**THE APEX - LH
'GEORGIAN'**

5-10-24 - INITIAL REDLINES - JJ

5-22-24 -Add Foundation Dimension & Roof Pitch Adjustment on the Garage roof - JJ

SHEET
1.2b

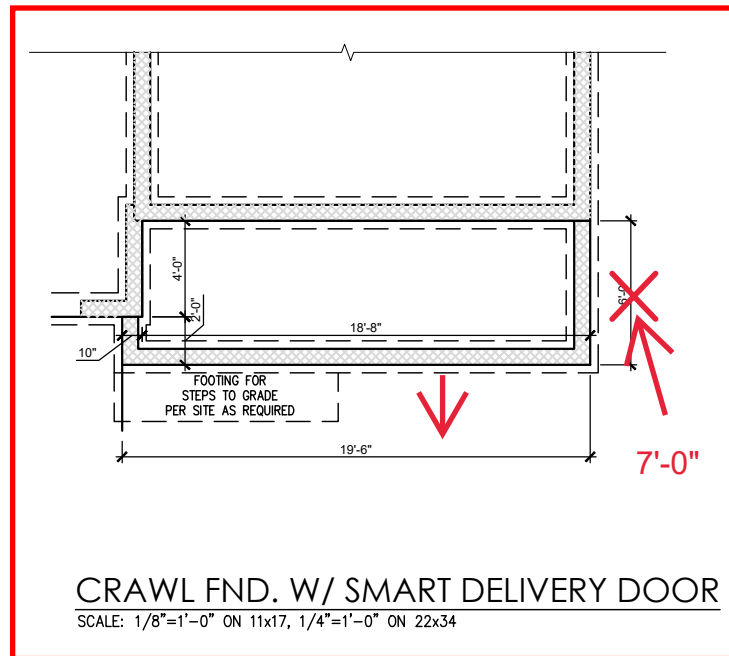
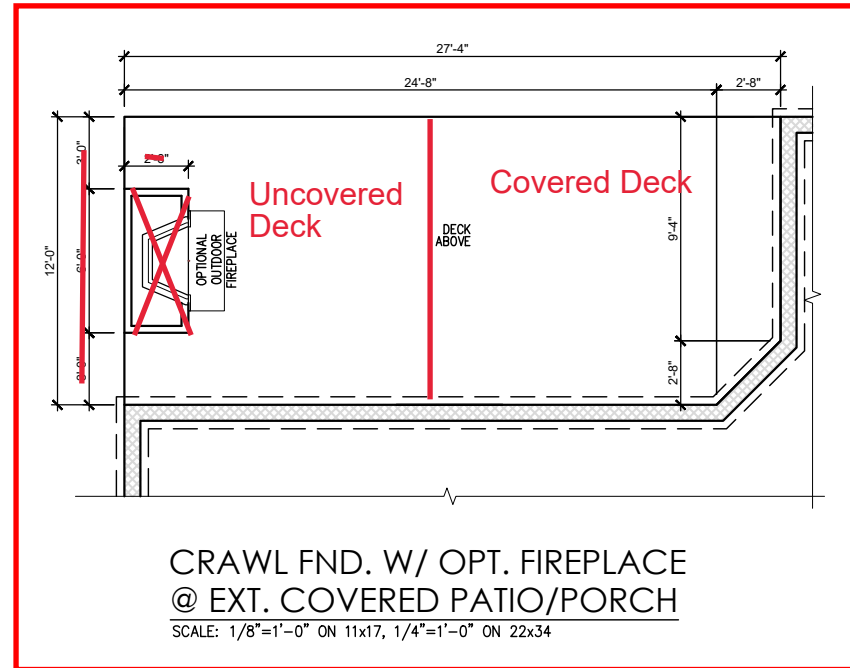
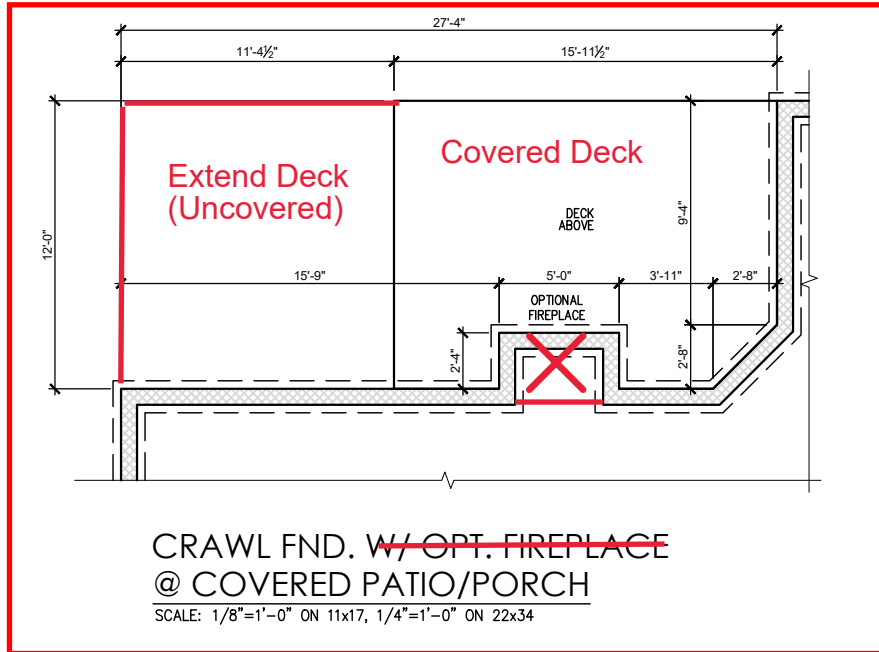
See Sheet 1.2.2b for third car garage and 2 car side load see new garage dimensions

See Sheet S-1.2.1b for Smart Door Delivery

SHEET
1.2.1b

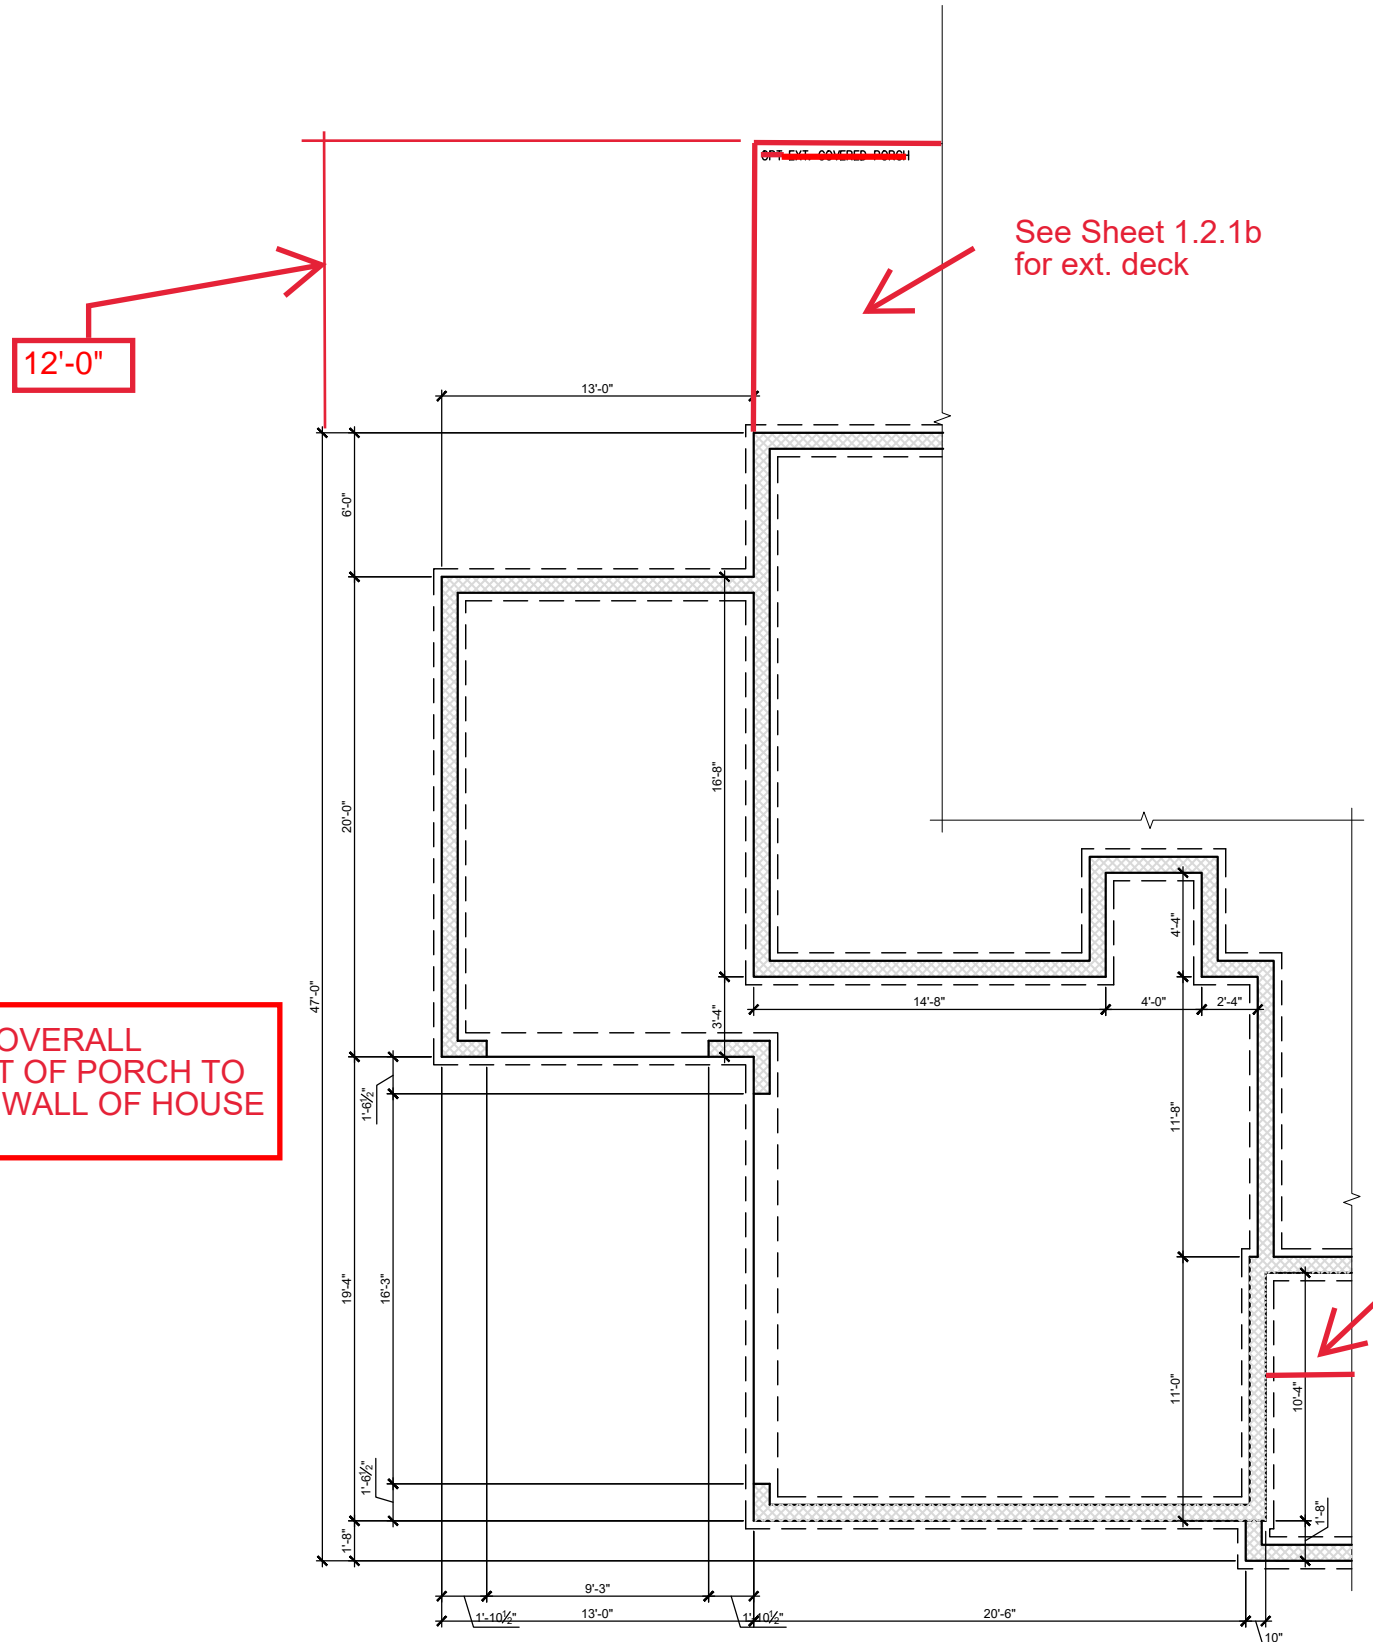
See Sheet 1.2.1b for ext. deck

See Sheet 1.2.1b for Smart Door Delivery

FIRST FLOOR PLAN 'GEORGIAN'
SCALE: 1/8"=1'-0" ON 11x17, 1/4"=1'-0" ON 22x34

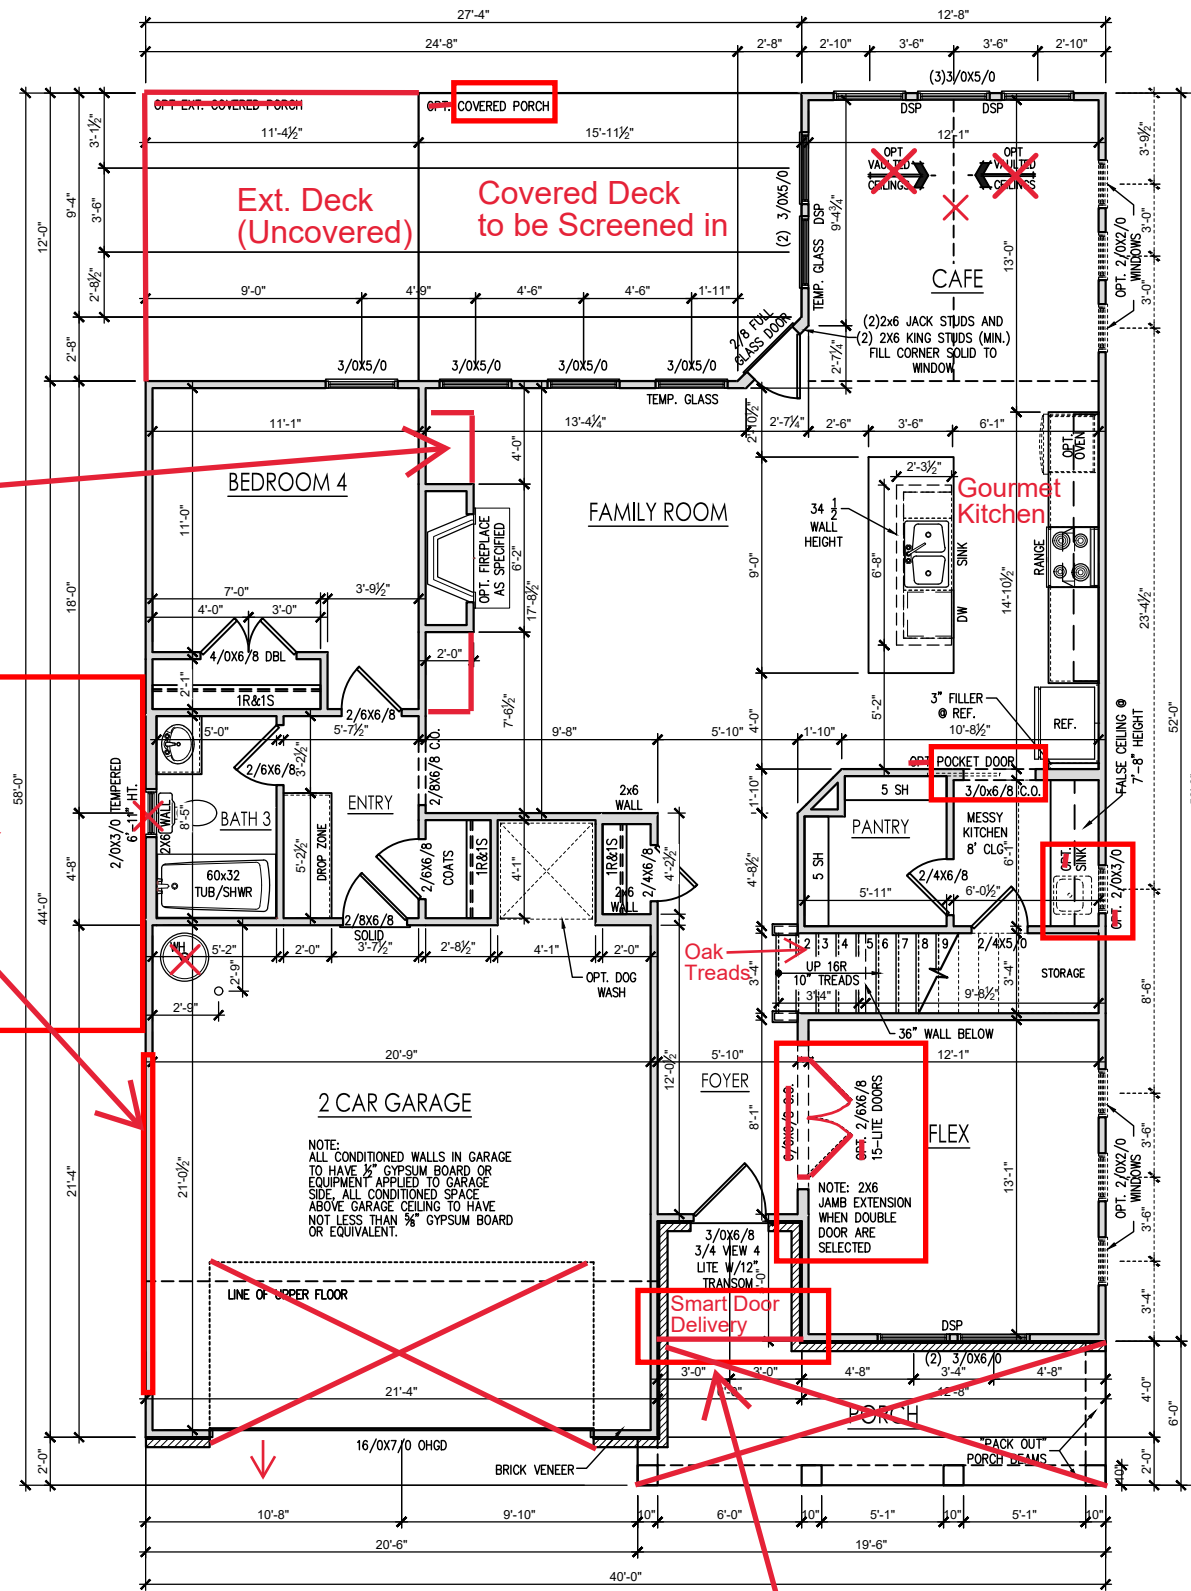
See Sheet S-2.4.3 for Ext. Cov. Porch

See Sheet 2.1.1b for built ins

See Sheet 2.8b for third car garage and 2 car side entry

See Sheet 2.1.1b for smart door delivery

**OPT. 2 SIDE LOAD W/ 3-CAR GARAGE
'GEORGIAN' FLOOR PLAN**
SCALE: 1/4" = 1'-0" ON 22x34, 1/8" = 1'-0" ON 11x17

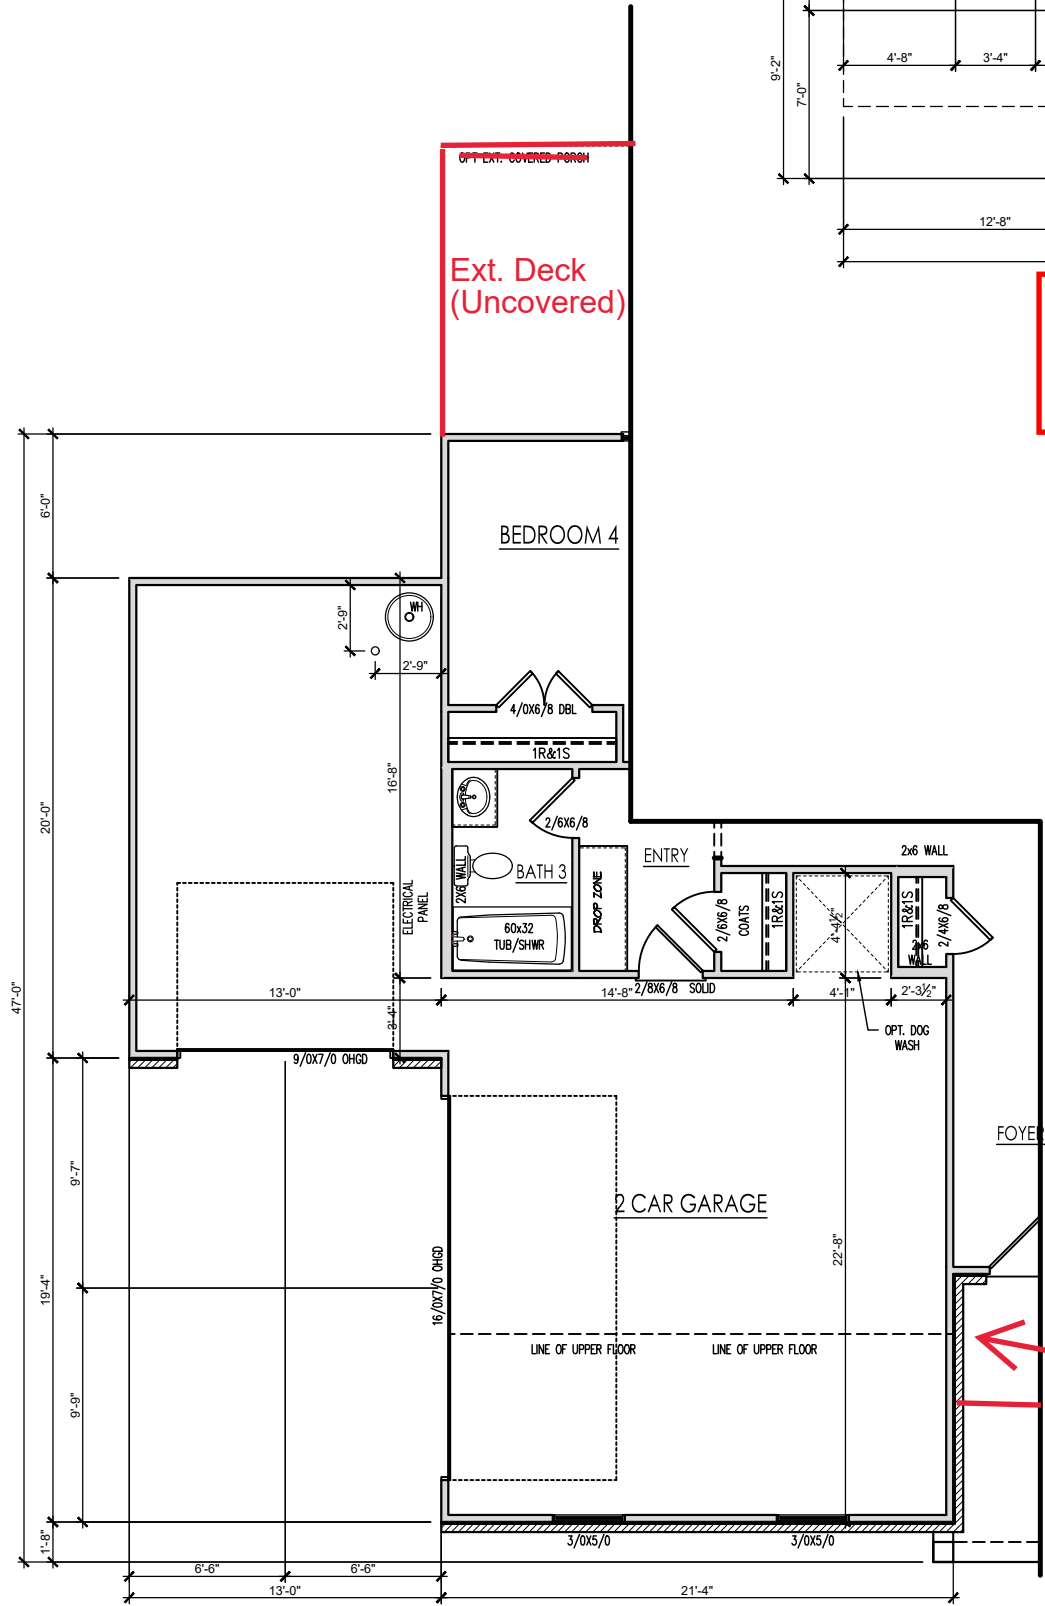
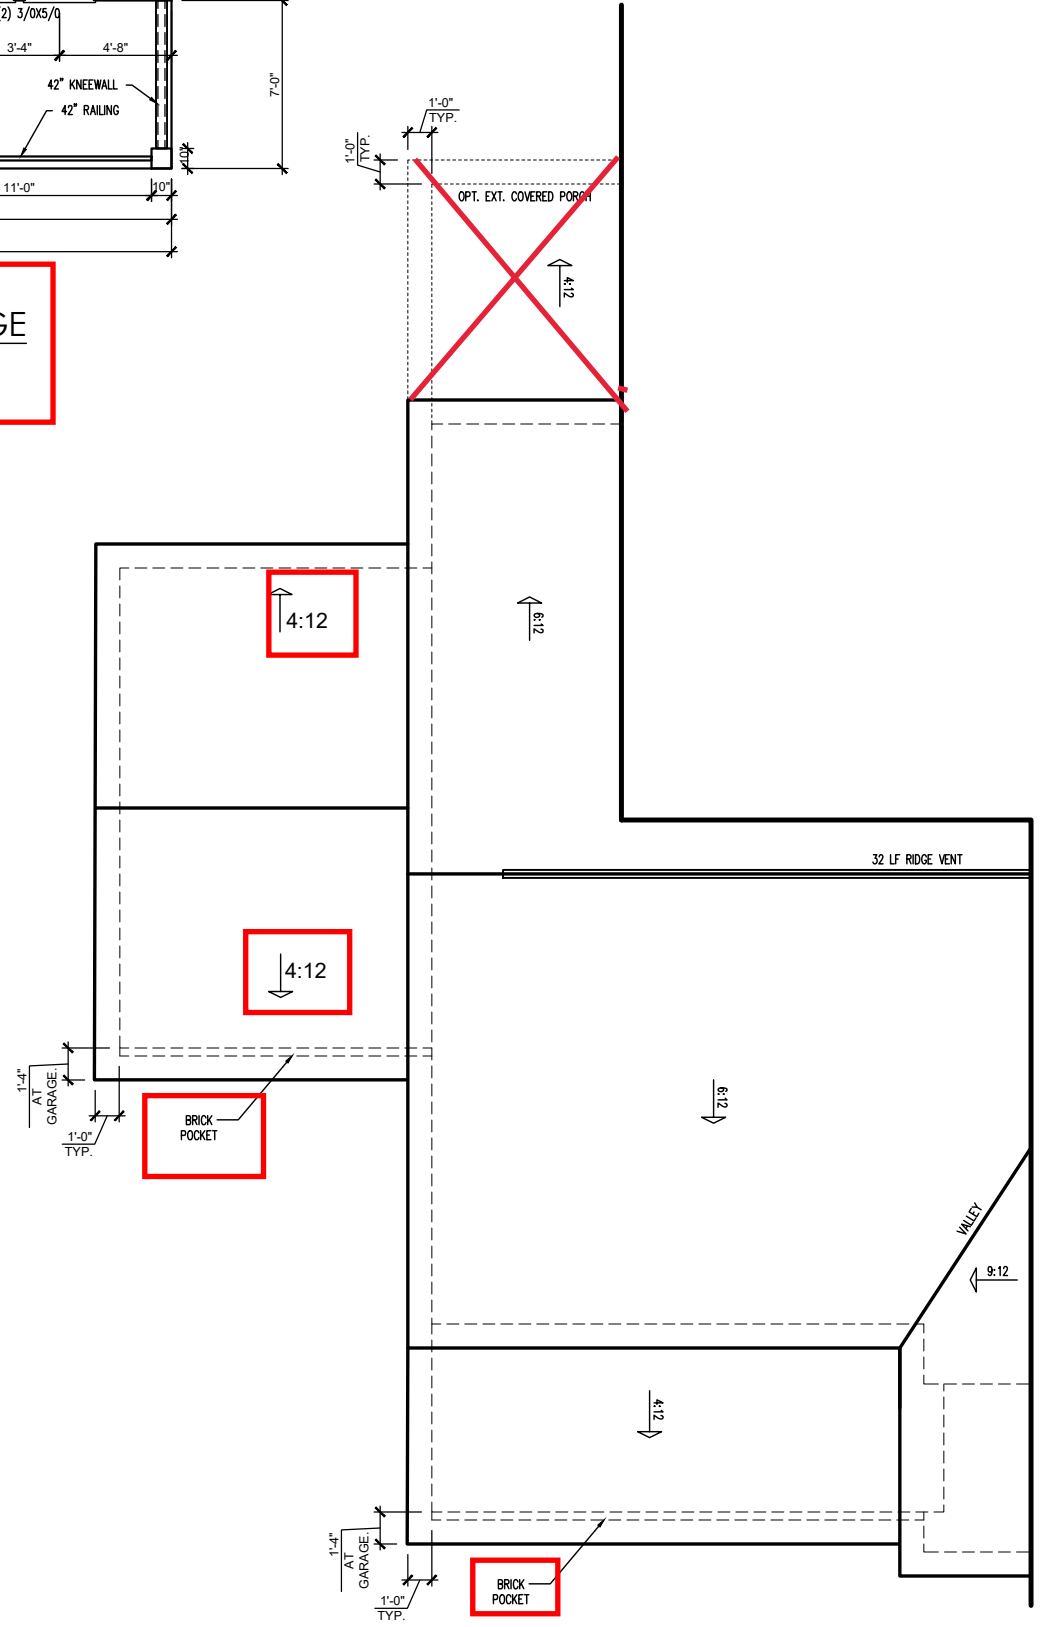
Ext. Deck
(Uncovered)

See Sheet
2.1.1b for
Smart Door Delivery
